# CITY OF ALBUQUERQUE

RE: Lot 7 Block 10 Unit 22 Volcano Cliffs SAD 228 6408 Petirrojo NW Grading and Drainage Plan Engineers Stamp Date 2/15/19 (D10D003F7) Pad Certification Date 2/15/19

Based upon the information provided in your submittal received 9/24/18, this plan cannot be approved for Building Permit until the following comments are addressed.

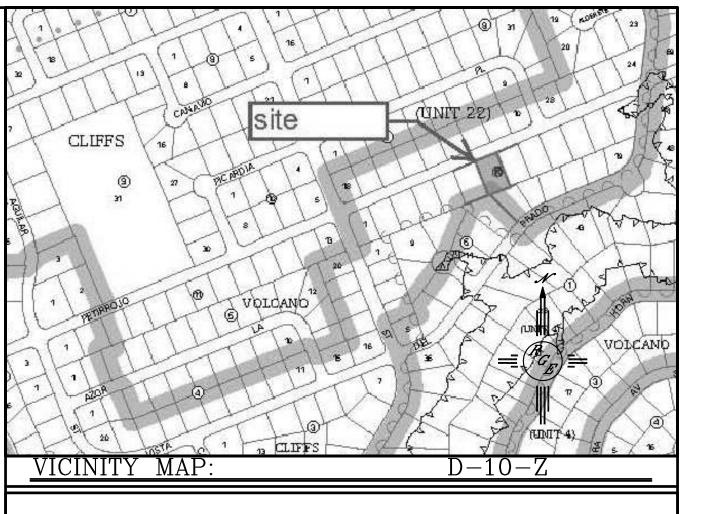
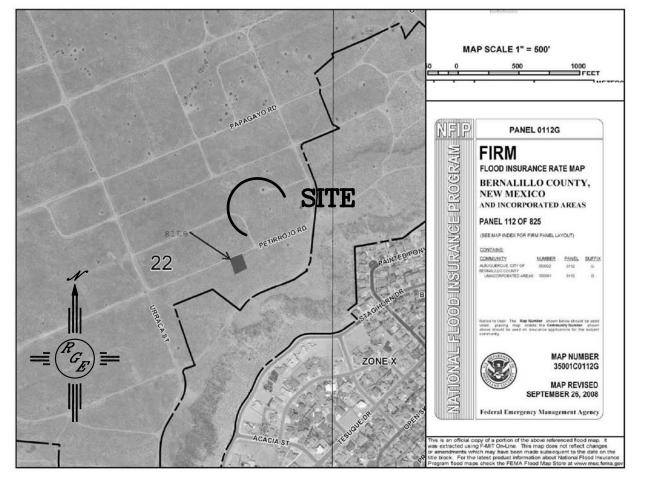
- Remove the dirt from the street being used as a ramp.
- Remove dirt piles on the sidewalk.
- FF and FP seem to be 3-4 feet lower than the street elevation, provide accurate FF-FP elevations.
